Planning and Development (Plan Variation No 329) Approval 2018

Notifiable instrument NI2018-428

Variation to the Territory Plan No 329

Weston group centre and surrounding community and leisure & accommodation lands:

Figure 3: Territory Plan provisions for the Weston Group Centre

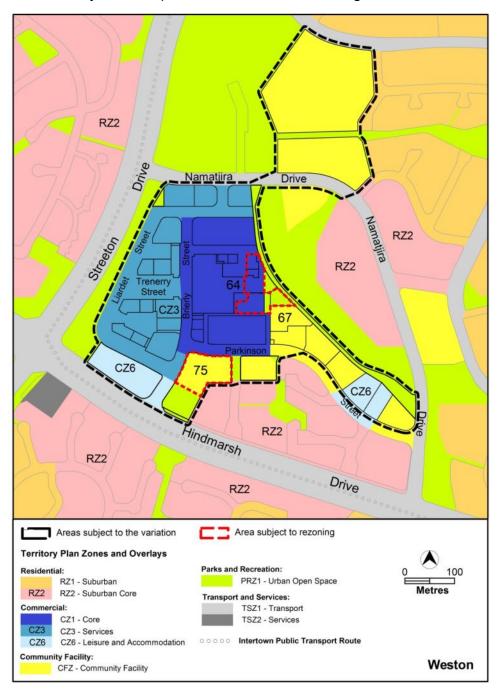
The Territory Plan map is varied as indicated in figure 3
